ADDENDUM #1

CHATTAHOOCHEE LIBRARY ADDITION

April 27th, 2026
 Drawing Questions/Clarifications

Chattahoochee Library Additions

SHEET TITLE
WALL TYPES / PARTITION

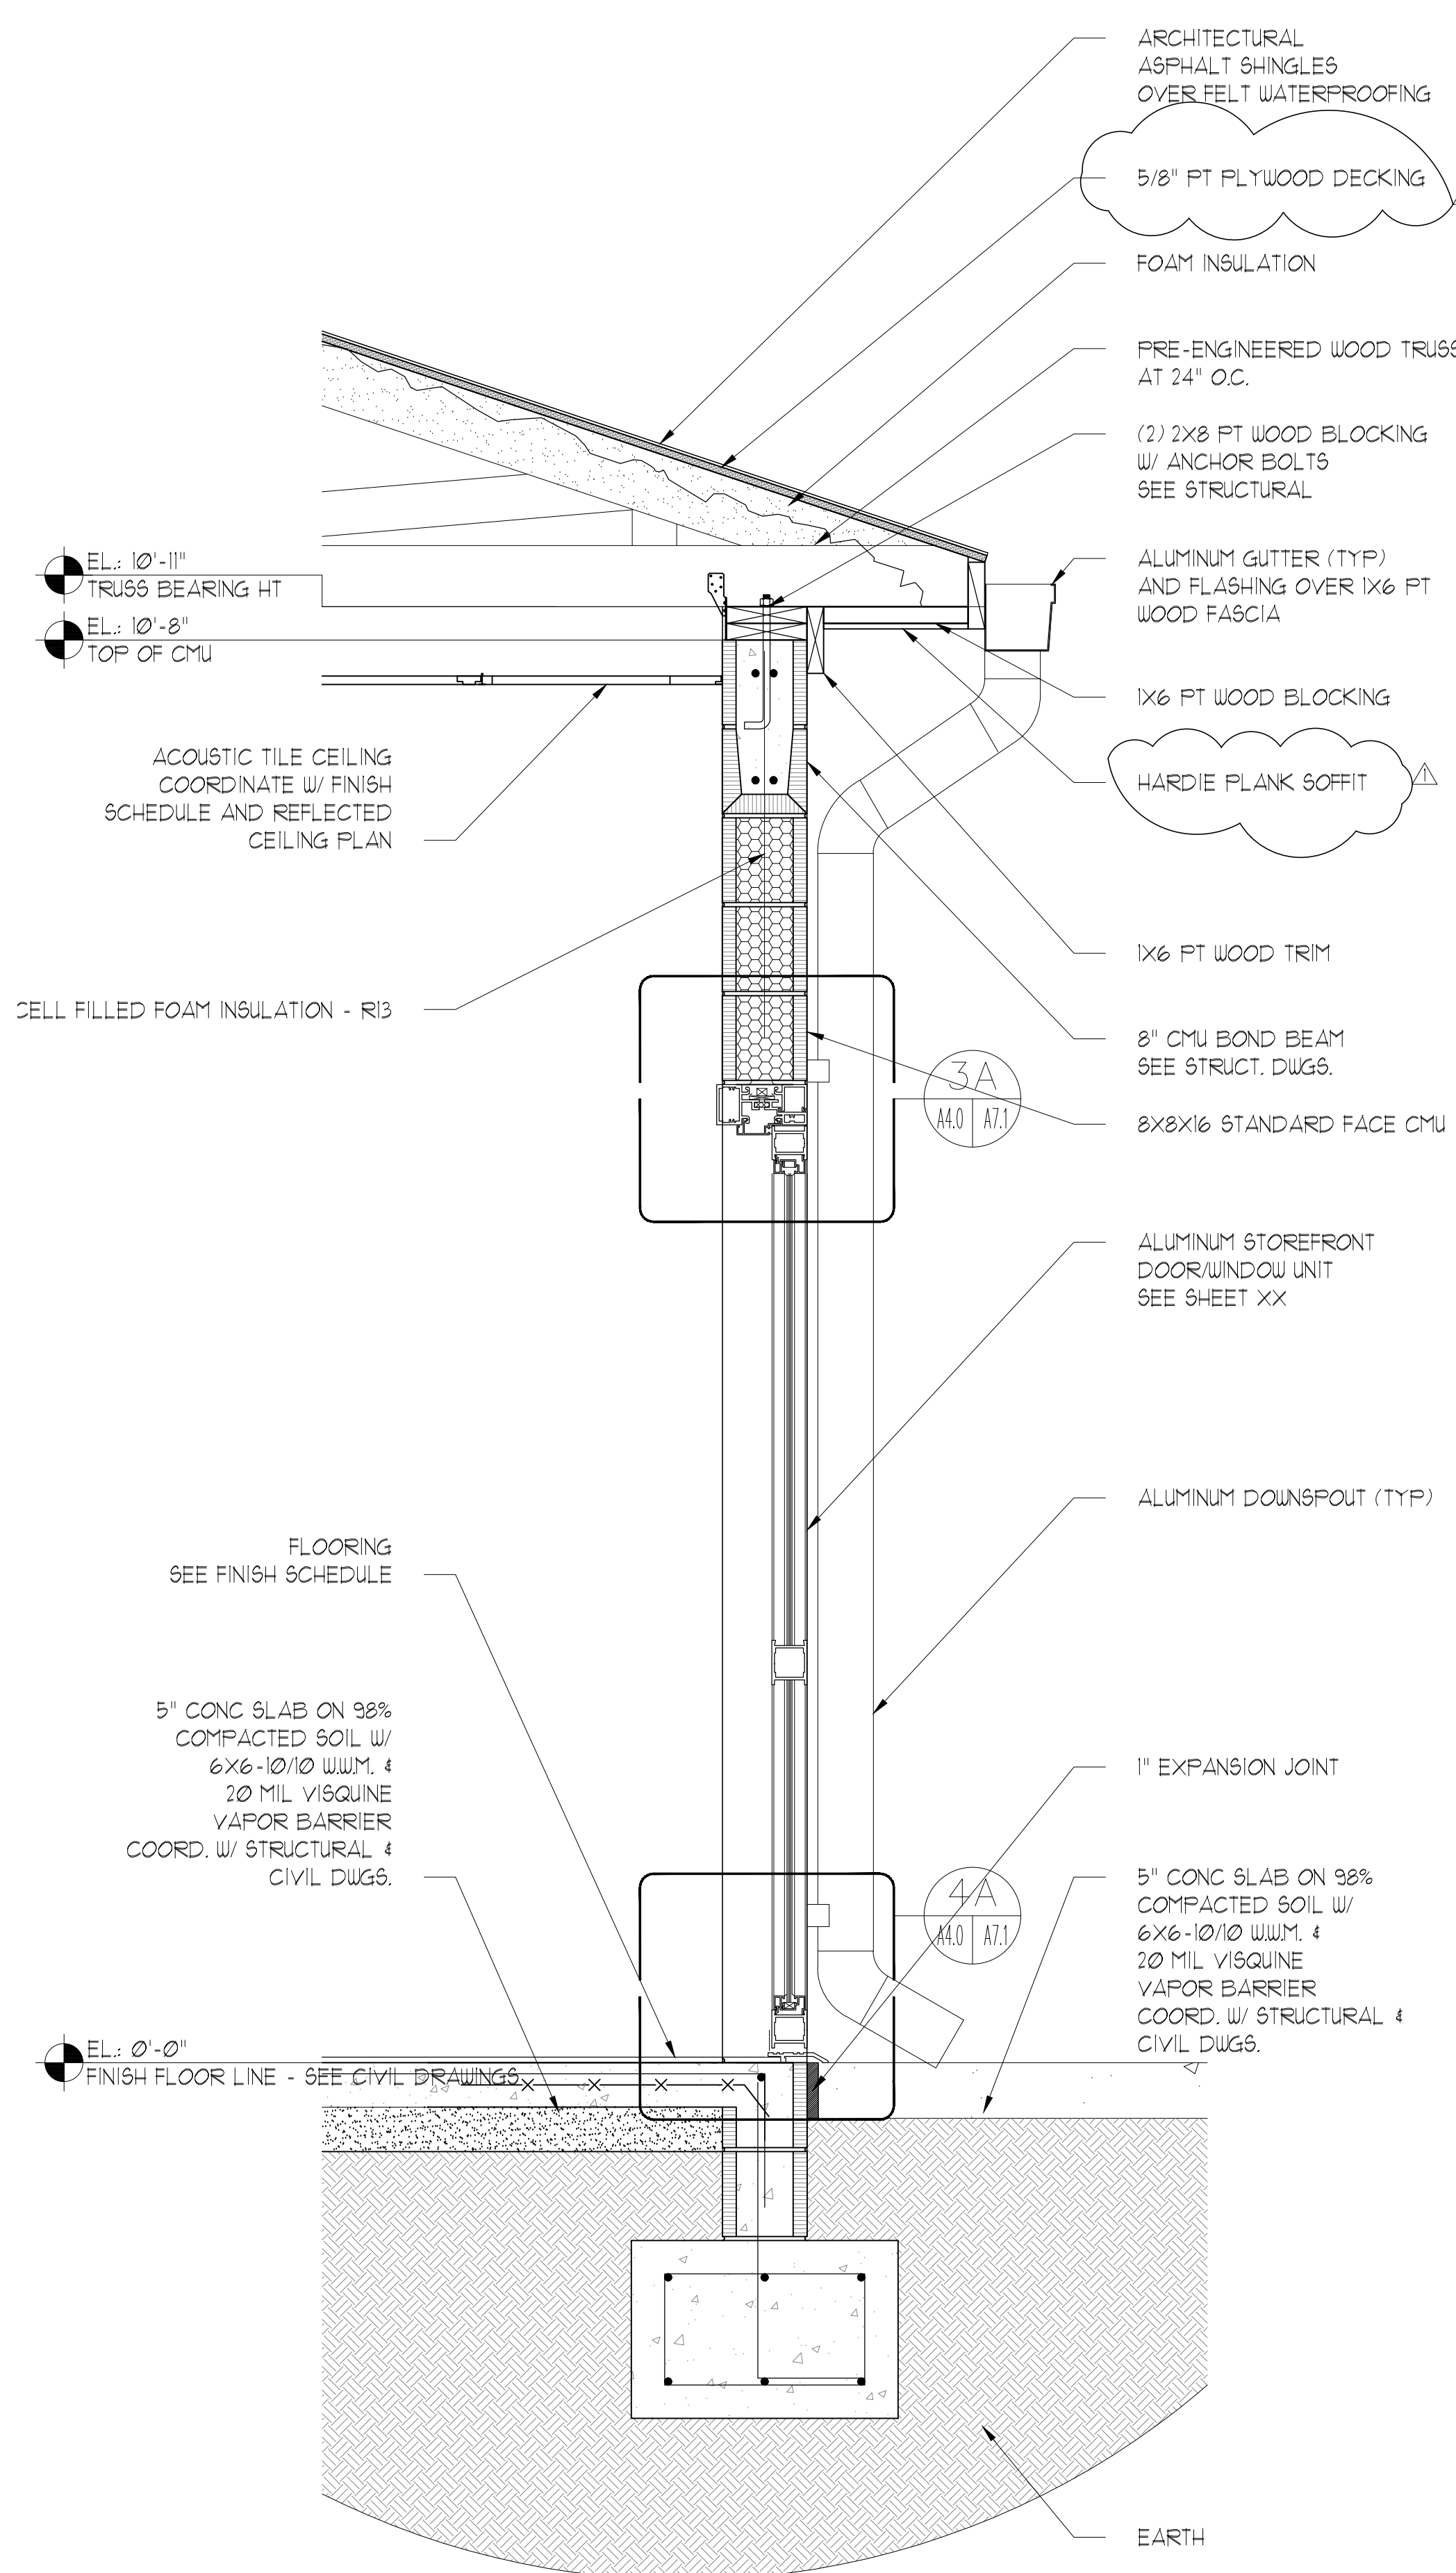
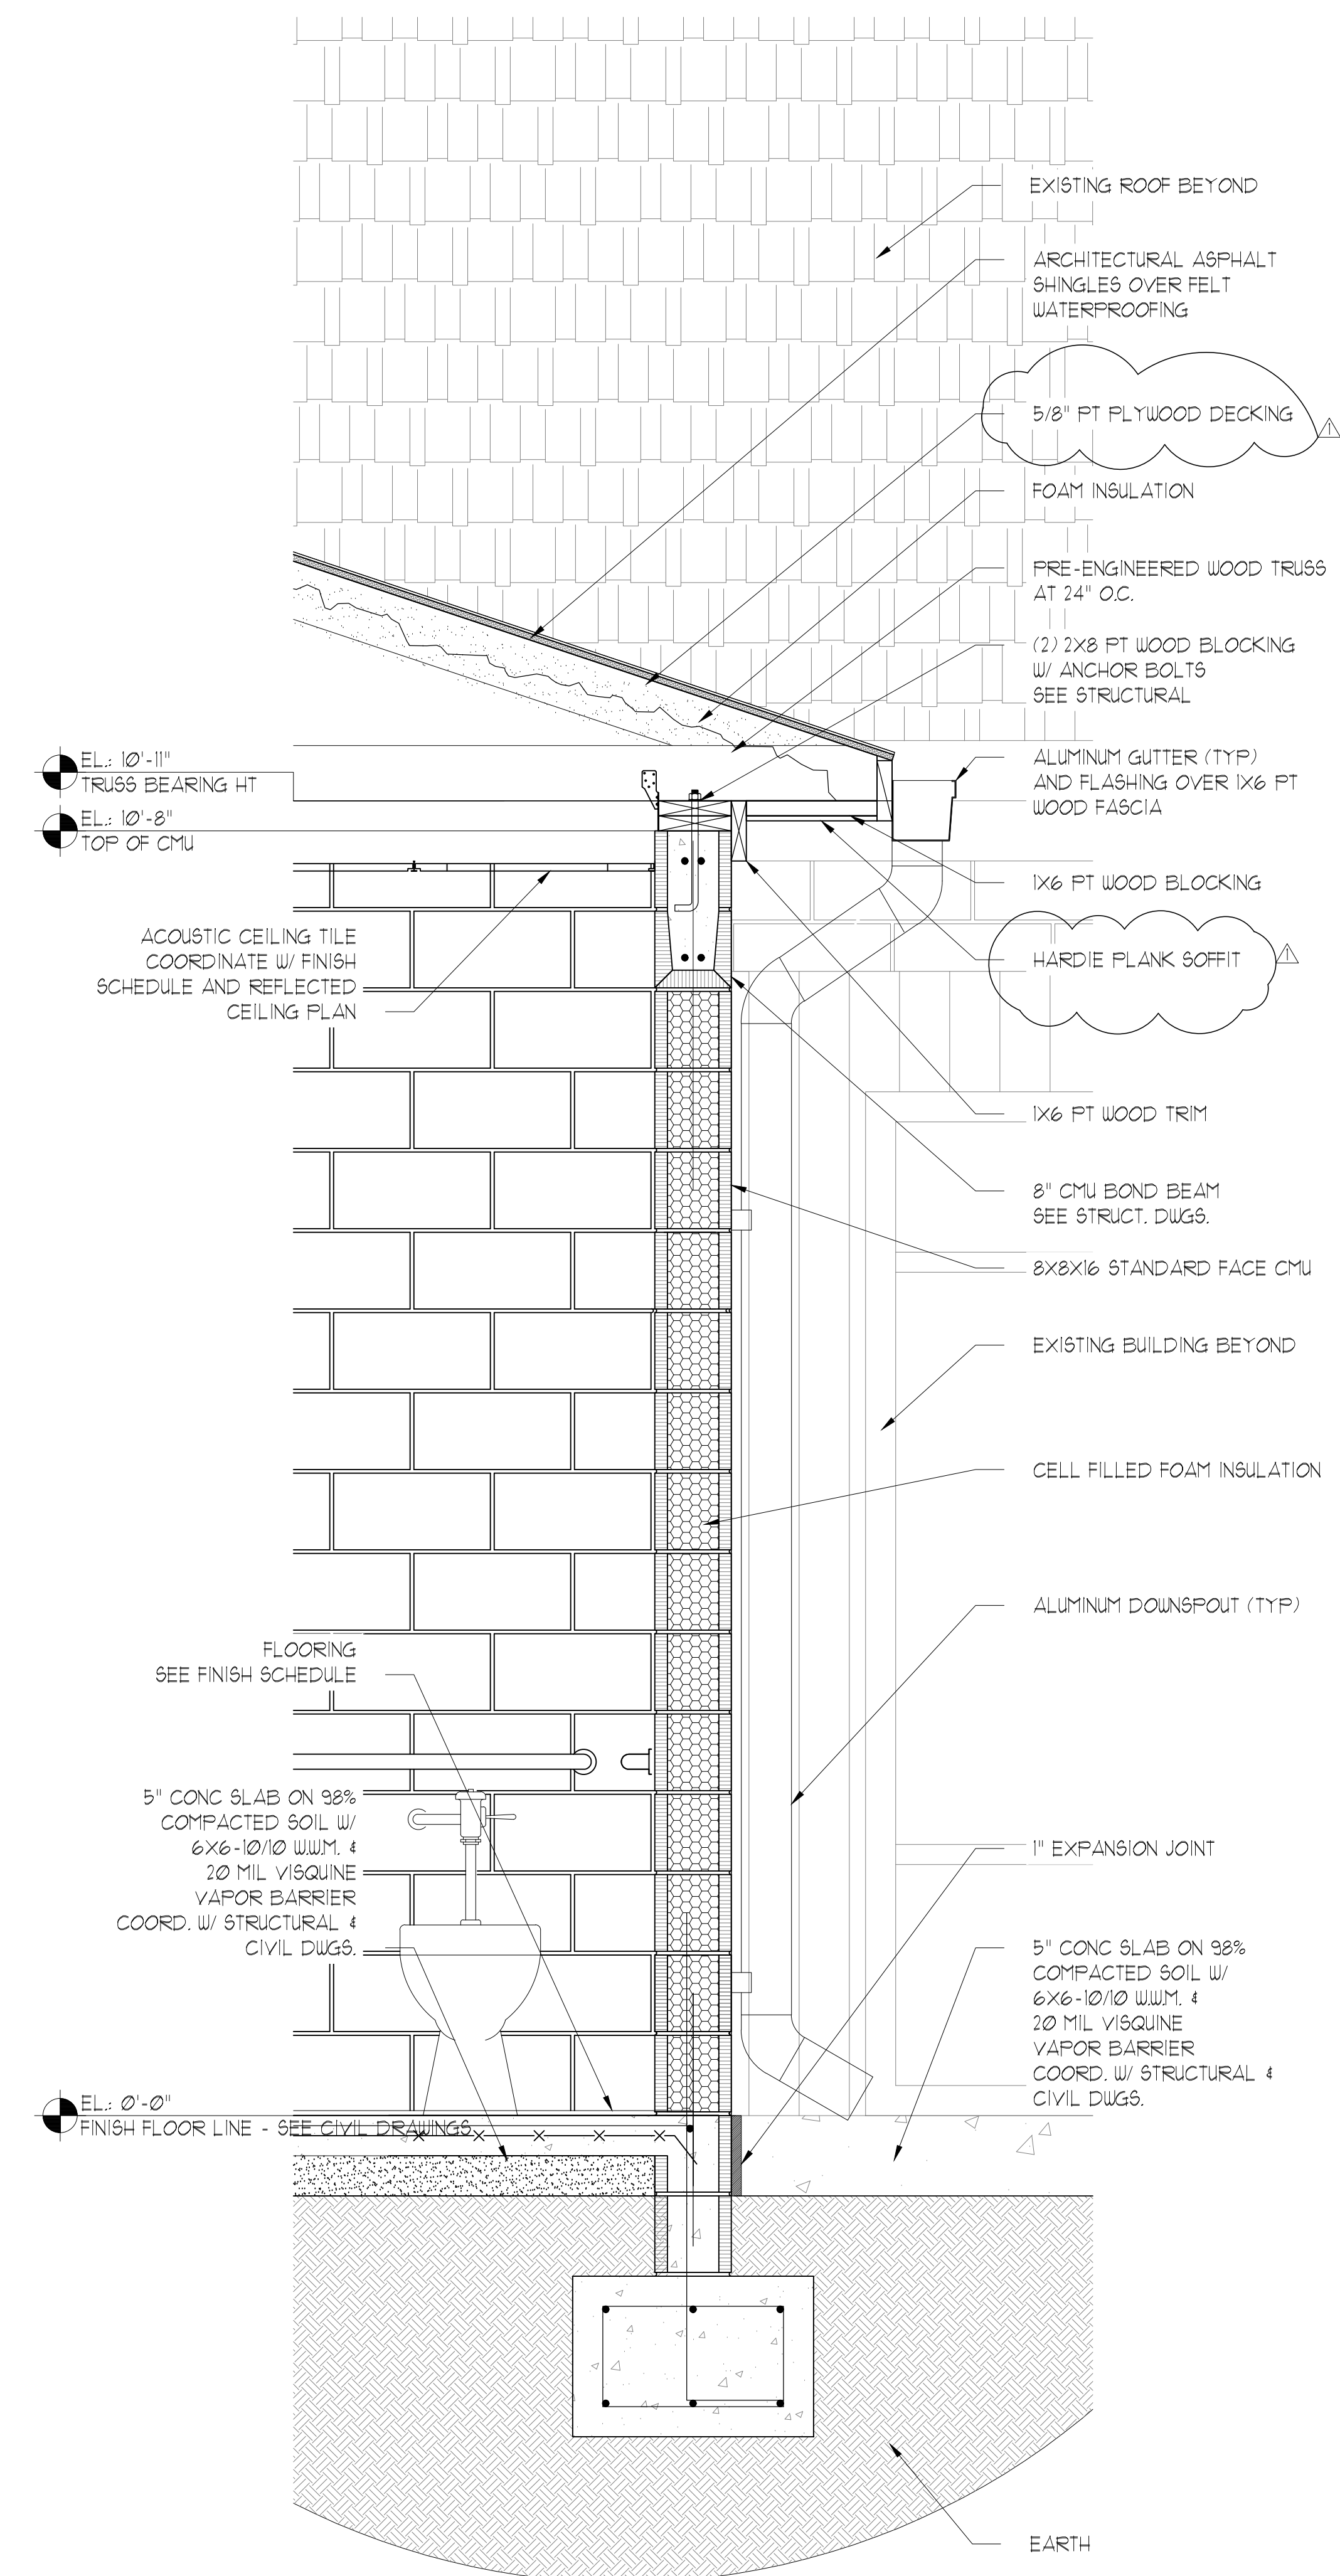
ITEM	Sheet Number	Questions/Clarifications
1	A1	Please Clarify if wall types 1 & 1A are going to Deck or going 4 inches above ceiling. Note revised see sheet A1.0
2	A6.0	"PT2" is called out for the Wall Finish in the Janitors Closet, but there is not PT2 noted on the Finish Schedule. Please provide details on the wall tile type for this callout. Tag revised see sheet A6.0
3	A6.0	Please provide further details on the Epoxy Paint to be Provided above the Wall Tiles in the Restrooms on all walls. Information is not provided on Color/Finish Legend See note 2.03 C.2 in specification section 099100
4	A6.0	Finish note 7 states "See wall tile Pattern on "A6.2". Sheet A6.2 is not provided nor shown on the drawing index. Note revised see sheet A6.0
5	A9.0 & A4.0	Detail D on Sheet A9.0 calls out a vinyl soffit, Section C on sheet A4.0 calls out hardie board. Please confirm which is to be provided Note revised see sheet A4.0 & 9.0

D ROOF EAVE W/ GUTTER
A-91 SCALE: 1 1/2"=1'-0"

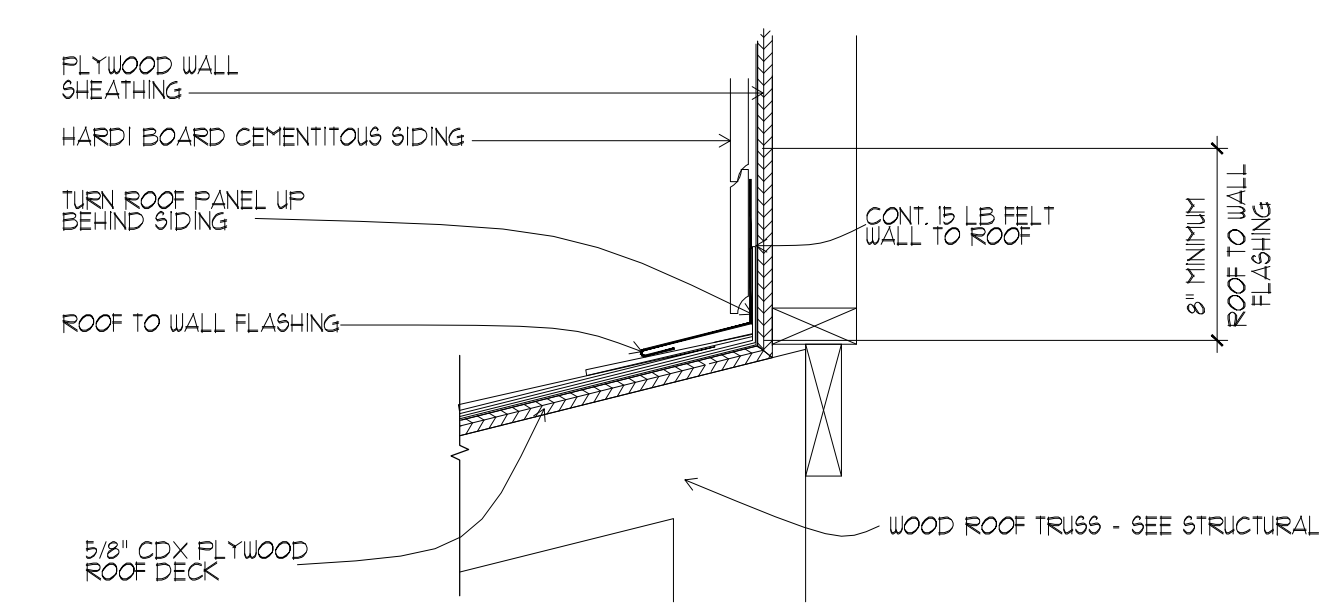
6	A9.0 & A4.0	Detail D on Sheet A9.0 calls out for 5/8" CDX Plywood roofdeck, Sections A,B, & C calls out 1/2" Plywood Decking. Please confirm which is to be provided. Note revised see sheet A4.0 & 9.0
7	A1.0 & All Architecturals	No Floor Plan Dimensions are provided on the Architectural Sheets. Please provide room/wall dimensions on sheet A1.0 and Architecturals. Dimension layer has been turned on see revised plans
8	S1.1	The 4" Column at Intersections 2/2 is shown to be inside a 3 5/8" wall. Please Advise.
